**PLANNED UNIT DEVELOPMENT
& SUBDIVISION STAFF REPORT****Date: July 2, 2009****DEVELOPMENT NAME**

South China Subdivision

CONTEMPLATED USEPlanned Unit Development Approval to allow shared
access and parking between two building sites, and
Subdivision Approval to create two legal lots from three
metes and bounds parcels.**TIME SCHEDULE
FOR DEVELOPMENT**

SITE PLAN

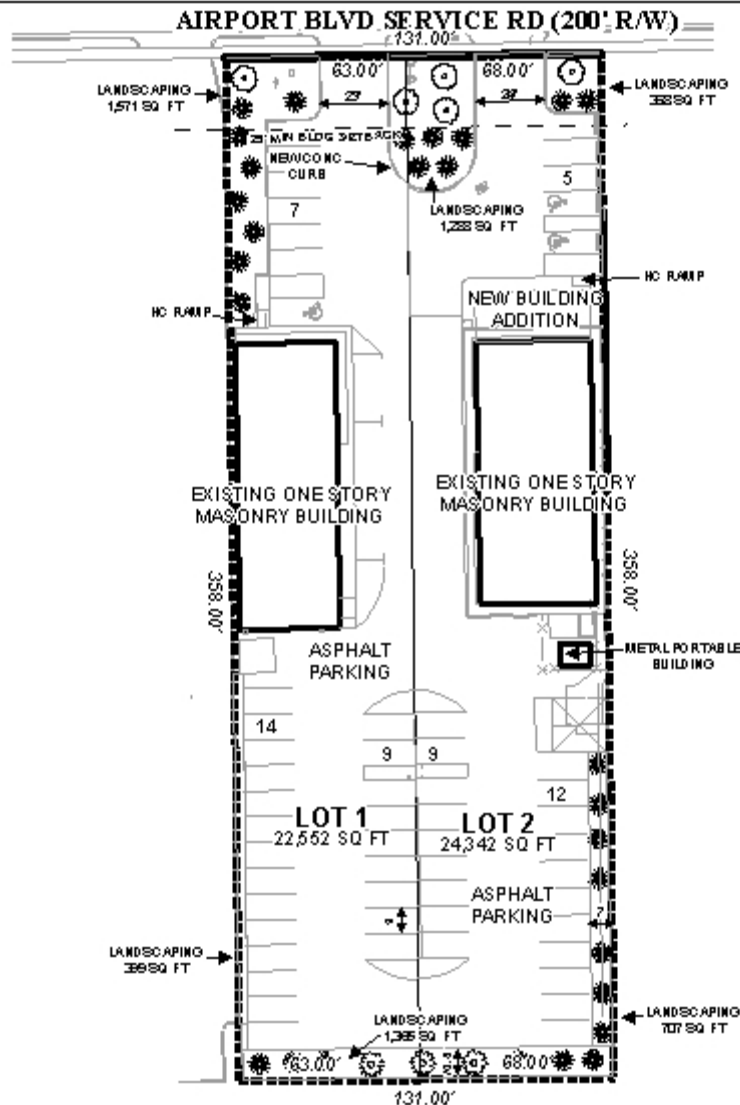
*Revised Traffic comments: Driveway number, size, location, and design to be
approved by Traffic Engineering and conform to AASHTO standards. The parking area on the
northeast side of the lot does not have adequate parking aisle width. A minimum of twenty-four feet
aisle width is required for ninety degree parking spaces. Standard widths for one-way drives are
between fourteen and sixteen feet. The two driveways shown exceed the maximum allowable width.*

Changes should be made to accommodate the standards. One way drives should be signed and marked. If the two driveways shown are not intended to be one-way access, one drive should be eliminated.

Regarding the PUD, the site plan submitted indicates an existing 3,500 square foot retail building requiring 12 parking spaces on Lot 1 and an existing 3,730 square foot restaurant requiring 38 parking spaces on proposed Lot 2. The site plan submitted indicates all property line setbacks to be compliant, and site coverage is determined to be compliant due to the site coverage calculations given. It should be noted that the site plan indicates a 680 square feet, 17-foot x 40-foot expansion proposed for the restaurant, which would require an additional seven parking spaces for a total requirement of 57 spaces, only 55 are illustrated of which two are located on the clean out of the grease traps.

Internal circulation and parking is indicated; however, areas for truck loading/unloading, if any, are not indicated. The existing curb cuts to Airport Boulevard are shown to remain. Parking calculations are provided based on the square footage of each use of the buildings, the calculations are not correct based on the existing uses of the buildings and landscaping areas and tree plantings are shown and calculations provided that comply with the landscaping and tree requirements of the Ordinance.

No storm water detention area is indicated, but no verification is furnished that such would not be required. No dumpster is depicted on the site plan.

While the PUD site plan was revised to illustrate compliance with Traffic comments, it does not illustrate dumpster locations and buffering or lighting standards as required in Sections 64-4.2 and 64-4.A.3.C of the Zoning Ordinance.

- 1) *placement of a note on the final plat stating that curb-cuts for the development are limited to the approved Planned Unit Development, with the size, design and location of any new curb-cuts to be approved by Traffic Engineering and to conform to AASHTO standards;*
- 2) *revised site plans depicting full compliance with the tree and landscaping requirements of the Zoning Ordinance;*
- 3) *revision of the site plan to locate the proposed screened dumpster so that it is serviced from within the parking area of the development;*

- 4) *revision of the site plan to illustrate the compliance with Sections 64-4.A.2 and 64-6.A.3.C of the Zoning Ordinance;*
- 5) *submission of a revised PUD site plan prior to any request for land disturbance or building permits, and prior to the signing of the final plat;*
- 6) *the submission and approval of any variance applications prior to the issuance of any buildings permits for the proposed addition; and*
- 7) *full compliance with all other municipal codes and ordinances.*
